NUREG-0097

## **MARBLE HILL NUCLEAR GENERATING STATION UNITS 1 and 2**

Docket Nos. STN 50-546, STN 50-547

FINAL ENVIRONMENTAL STATEMENT

Fig. 8.1. PSI and NIPSCO Service Areas.  
Source: ER, Fig. 9.2-9

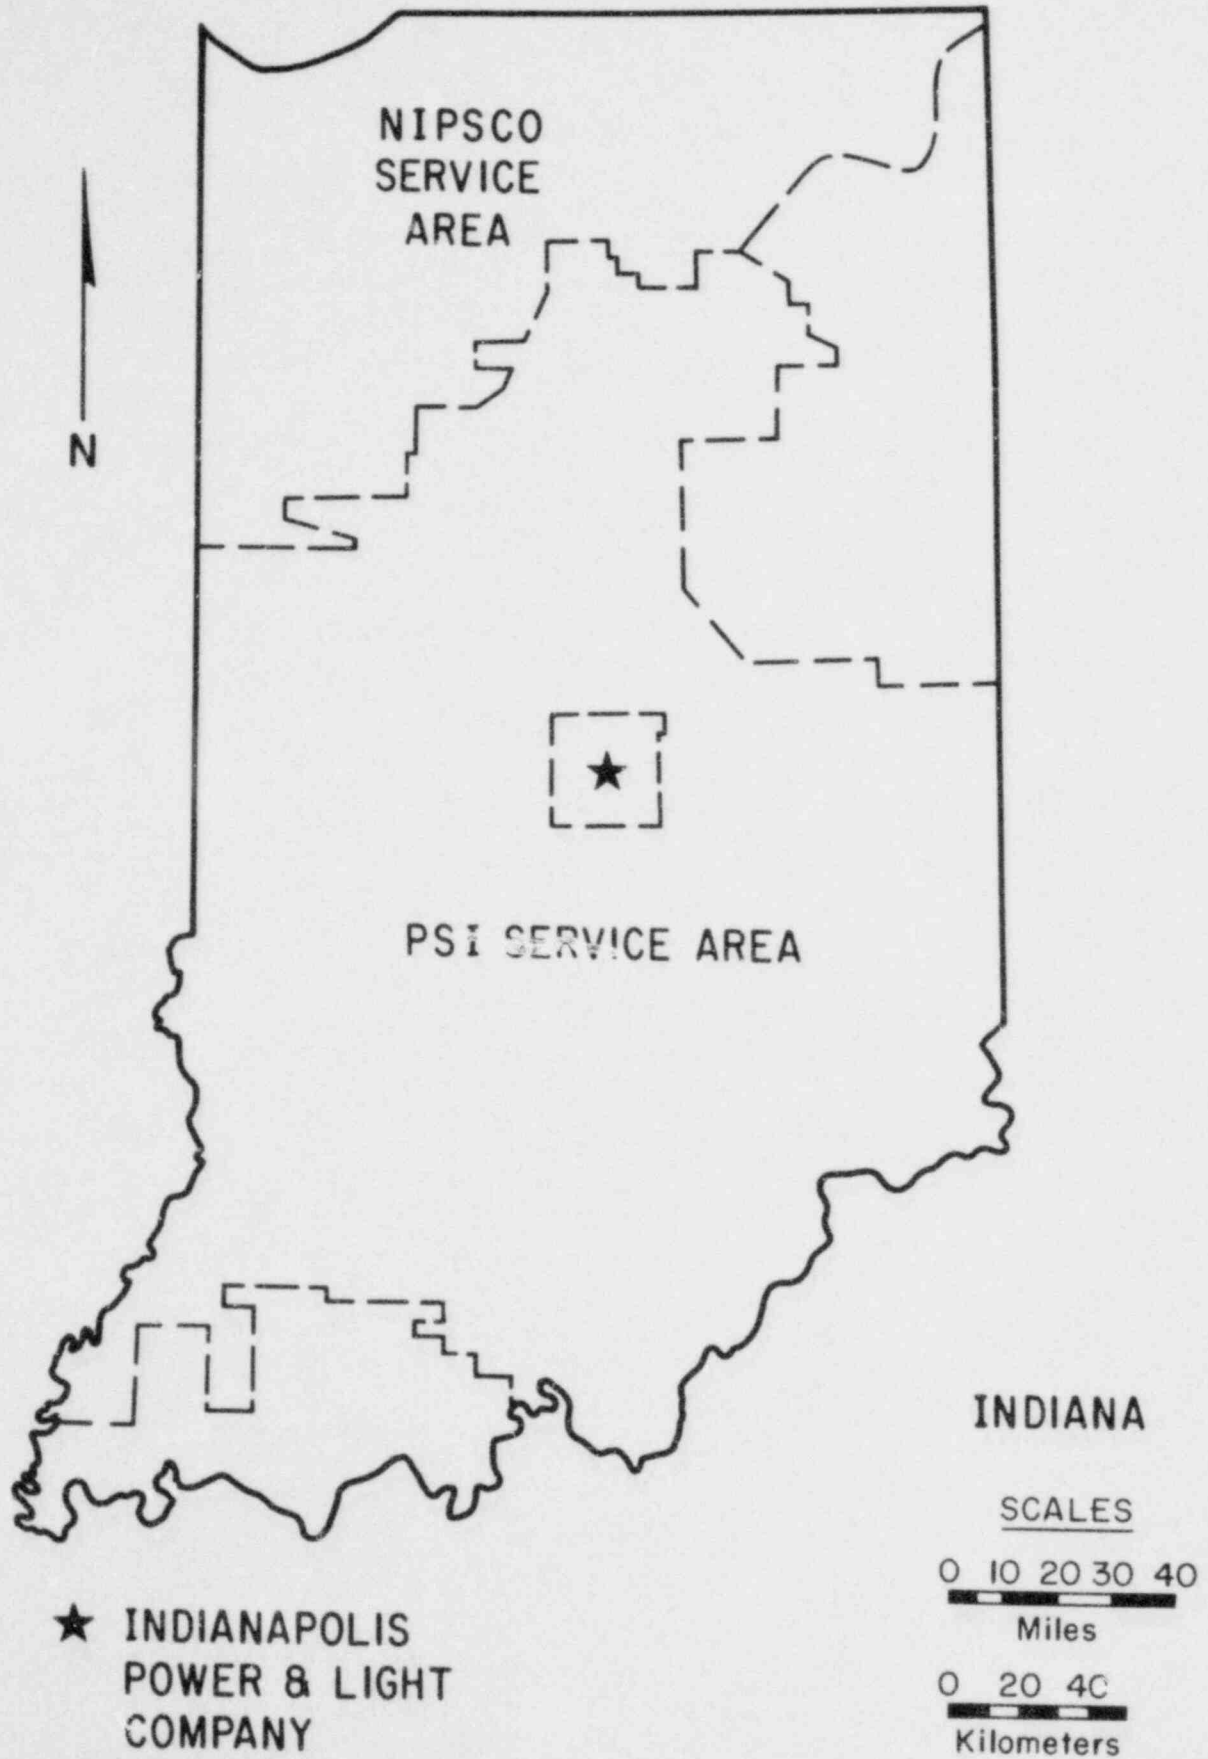
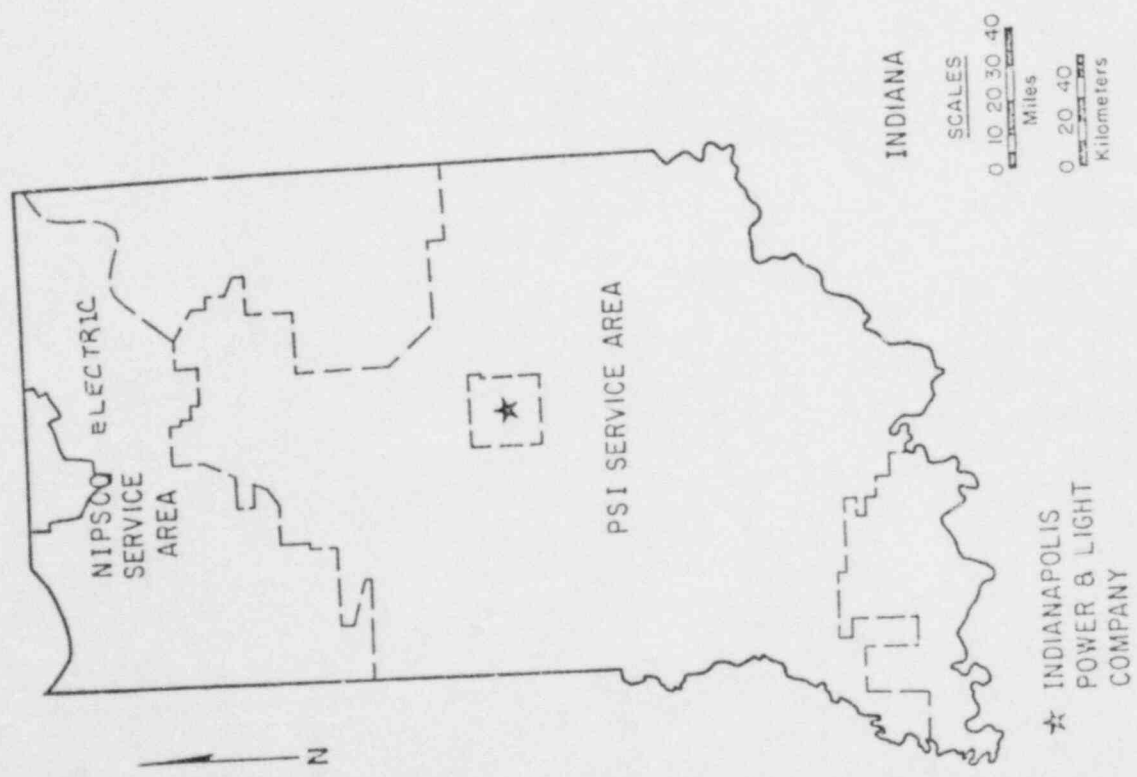
8-2	Figure 8.1	The NIPSCO service area should only indicate the electric service area which would necessitate the removal from the diagram of the South Bend-Elkhart areas that are served by I&M. (See attached Figure 8.1.) In addition, please amend "NIPSCO Service Area" to "NIPSCO Electric Service Area".
			8-5	Figure 8.4	Same comment as on Figure 8.1 concerning detection of service area. "NIPSCO" should refer to "NIPSCO Electric Service Area".
			8-10	Figure 8.6	Referring to "NOTE" below the figure, the statement "...the years 1960-1965 were characterized by 9.6% annual growth..." should read "7.6%".
			8-16	Figure 8.8	See corrections to attached Figure 8.8. In addition, delete the phrase "whose existence is in doubt".
			8-18	Table 8.2	See attached 8.2 for corrections. The percentage change for the future period (1975-1986) is no longer "Percentage Change In Sales To Customers," but is "Percentage Change In System Energy."

Fig. 8.5. PSI Annual System Energy Requirement

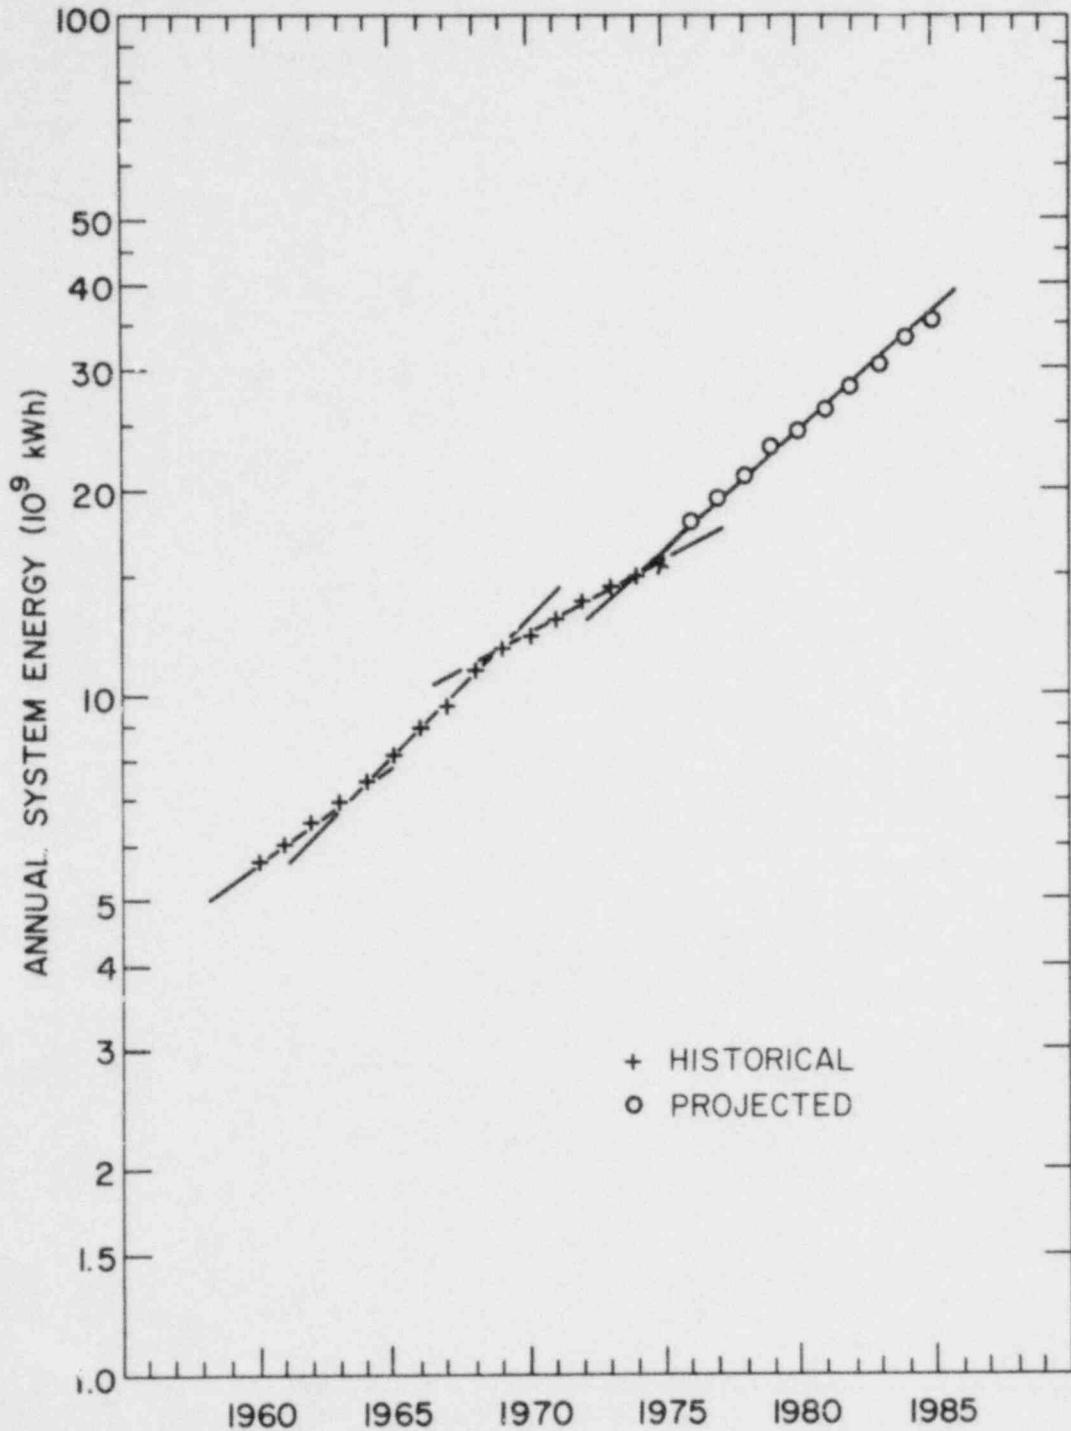
Fig. 8.5. PSI Annual System Energy Requirement (p. 8-9). COMMENT: PSI's historical and projected values are graphically illustrated in this Fig. and it is stated: "On the average, the years 1960-63 were characterized by 6.7% annual growth, 1963-1969 by 9.3%, and 1969-1974 by 5.0%". The latter appears to be approx. a 50% drop. For the record, PSI's 1972 Annual Report lists a 2% increase in customers at year-end and a 12.1% increase in net income, and 1973 lists a 2.1% customer increase with a corresponding 29.2% increase in net income. QUESTION: How do you equate this data with PSI's projected need of an average annual growth beginning in 1974 of 8.2%? (This writer feels an independent study by the General Accounting Office (GAO) is needed in this matter.)
